Origination Form
Proposed Revisions to a Standard Plans Index

Originator:	Turley, Joshua	Index Number:	455-031
Date:	5/15/2025	Sheet Number(s):	Sheet 1
E-mail:	Joshua.Turley@dot.state.fl.us	Index Title:	30" SQUARE PRESTRESSED CONCRETE PILE - HIGH MOMENT CAPACITY

LAST REVISION 05/01/25	DESCRIPTION:	 FY 2026-27 STANDARD PLANS	30" SQUARE PRESTRESSED CONCRETE PILE - HIGH MOMENT CAPACITY	INDEX 455-031	SHEET 1 of 1
------------------------------	--------------	--	--	------------------	-----------------

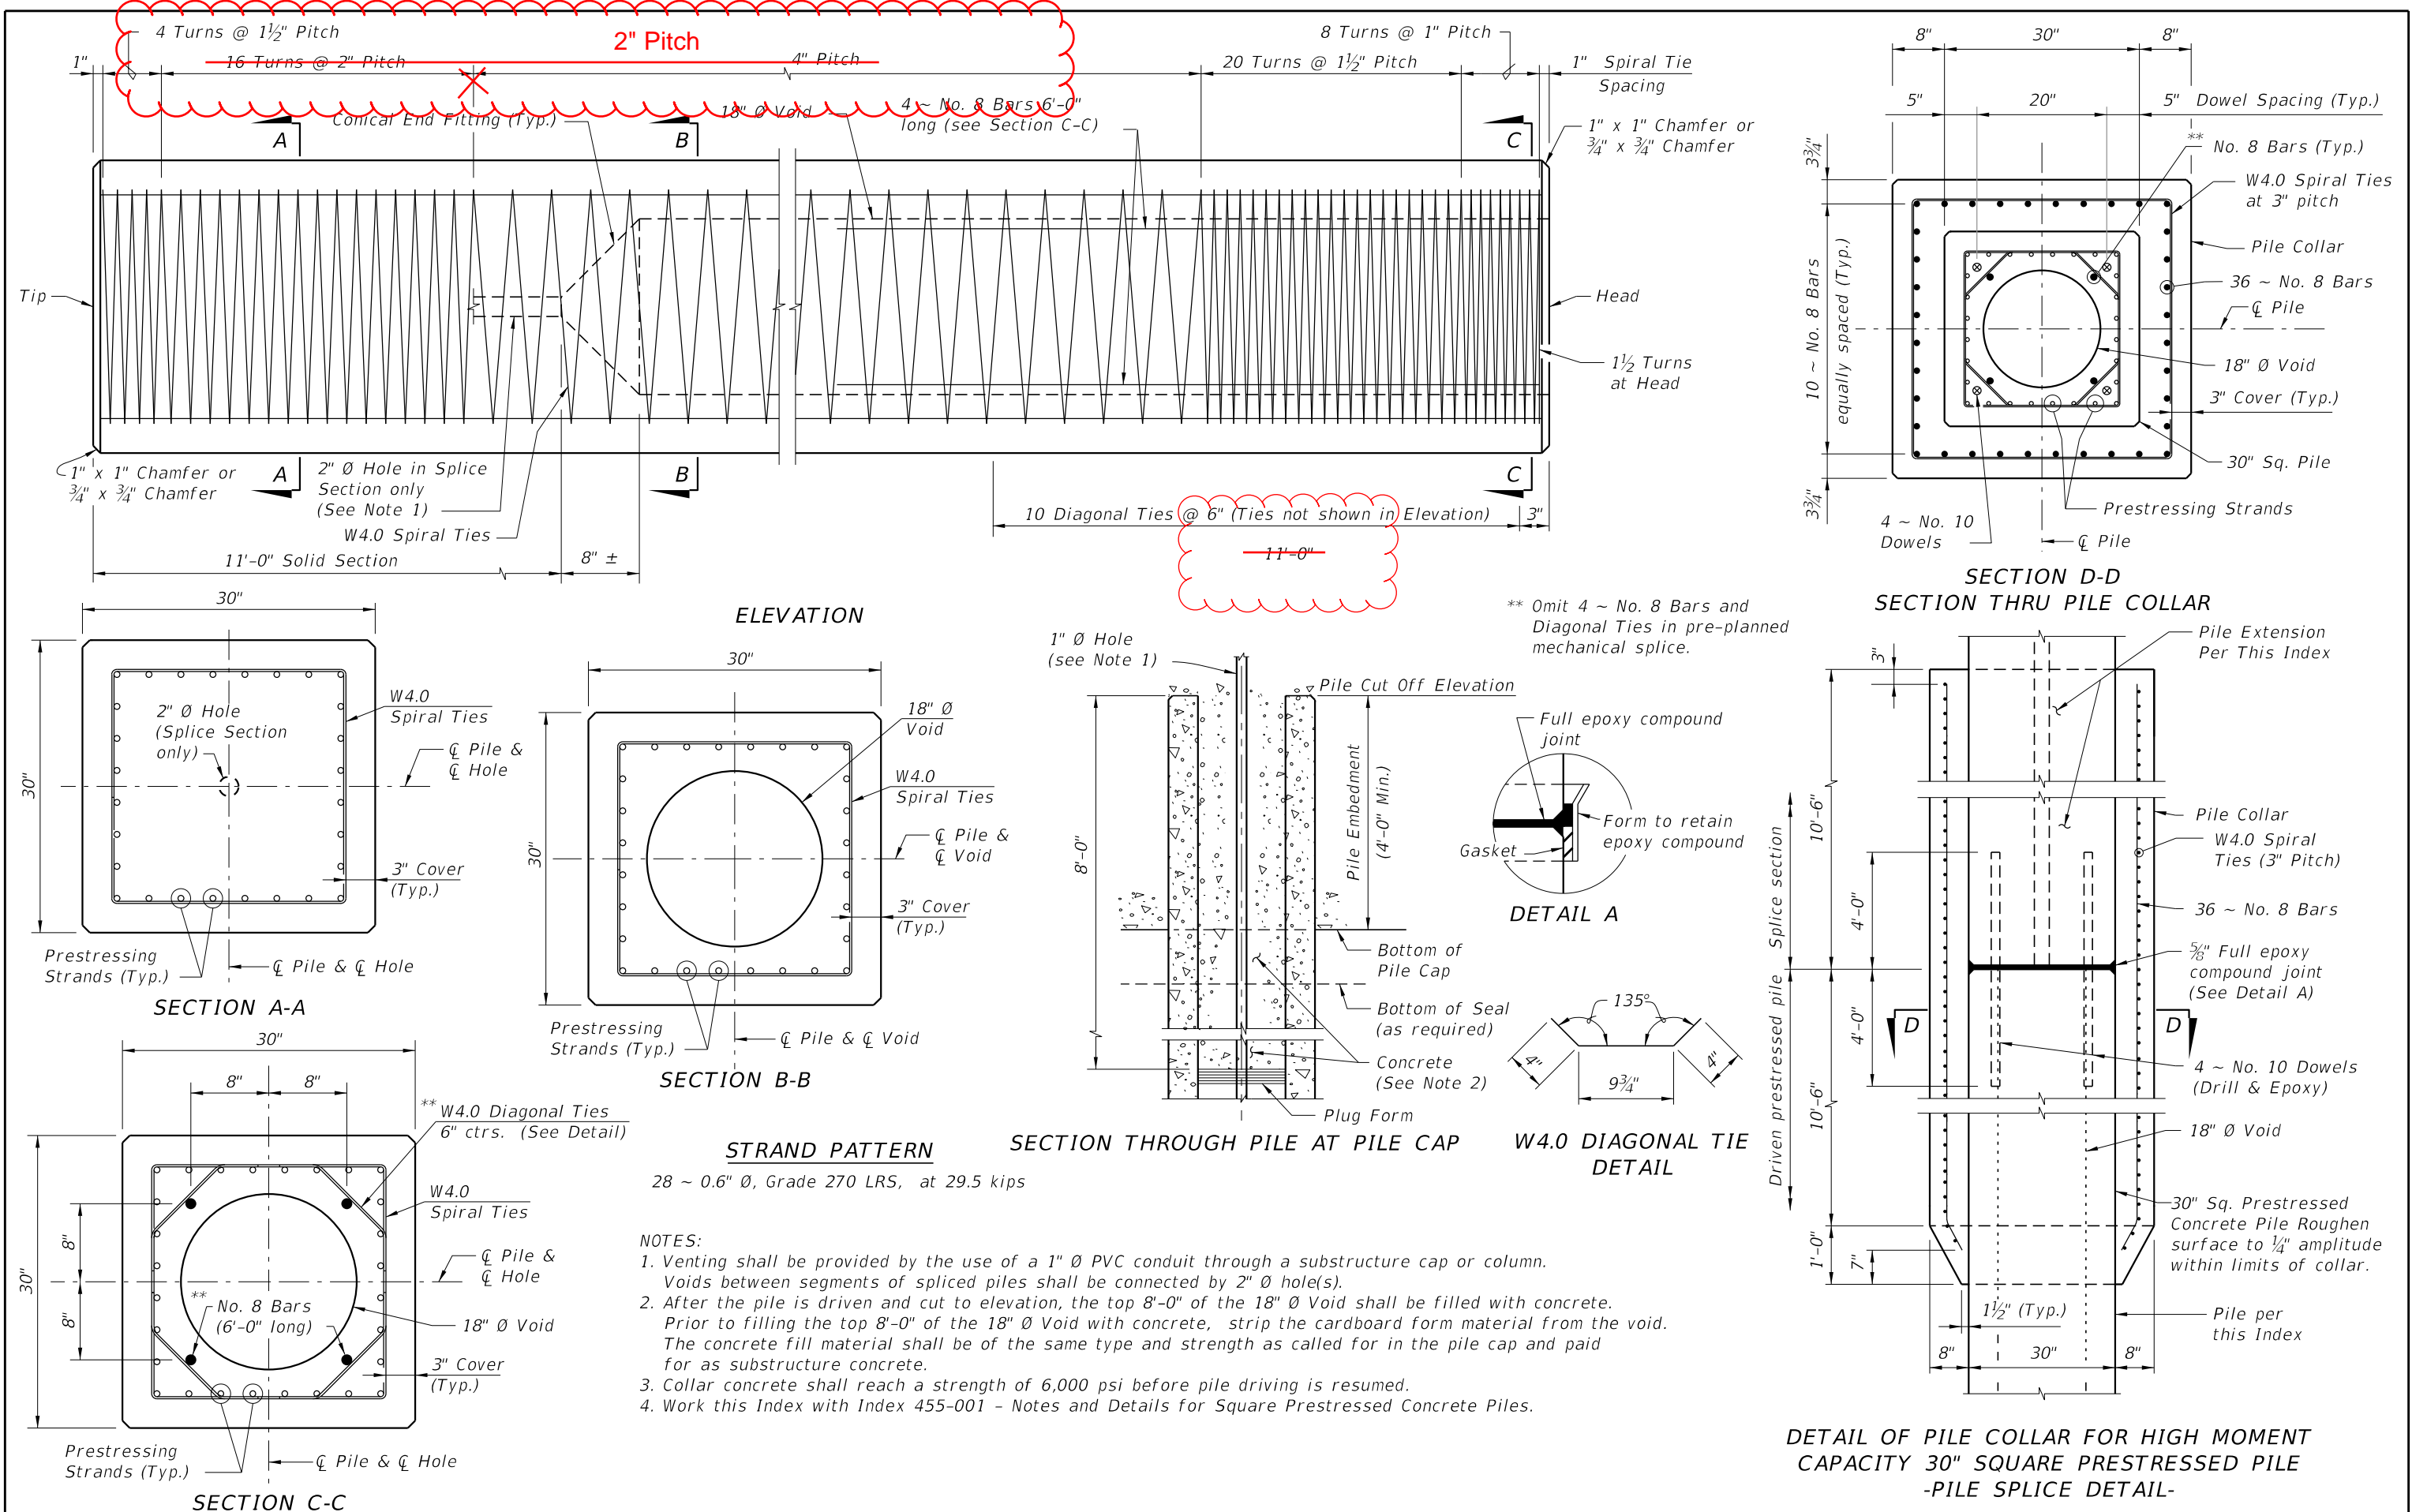
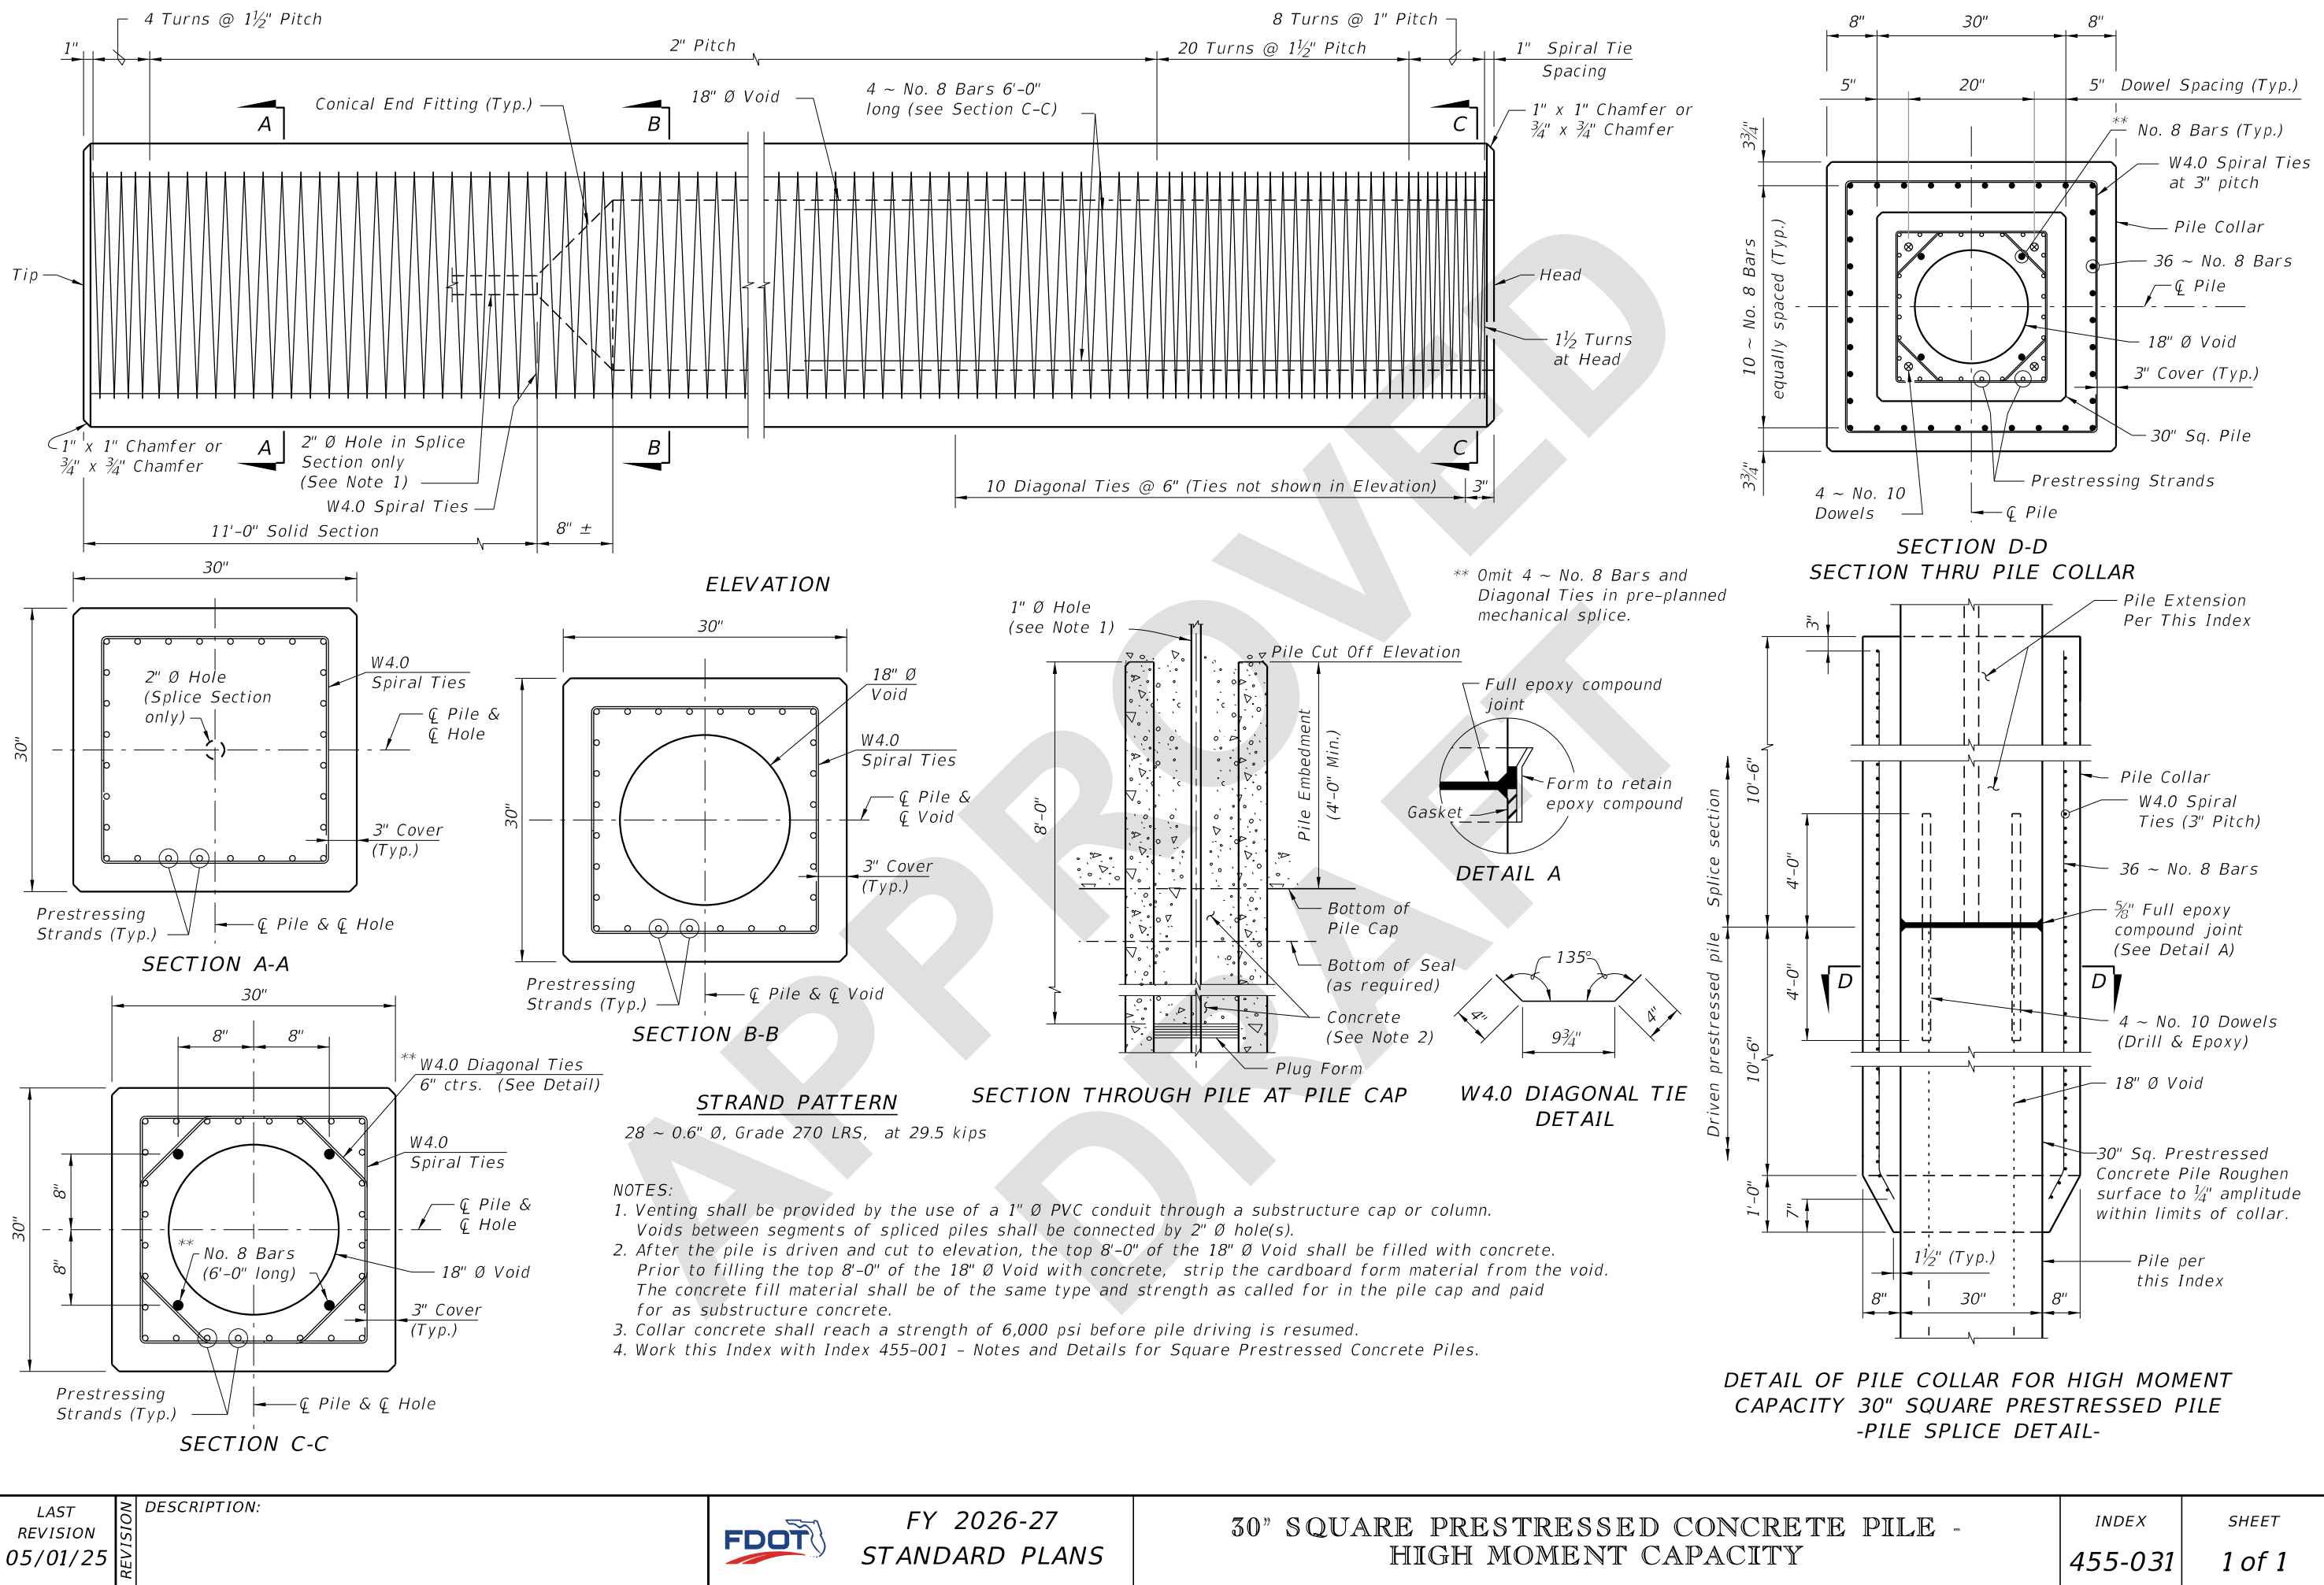
Sheet 1: Changed pitch spacing for spiral ties and removed errant 11' dimension which was a CAD error.

Vertical cracking has been observed in hollow core prestressed concrete piles, including 30-in. voided square HMC and conventional piles, and 60-in. hollow cylindrical piles, during installation and service. To address cracks frequently occur within the 4" stirrup pitch zone, a reduction in stirrup pitch to 2" is proposed to help mitigate cracking in these areas.
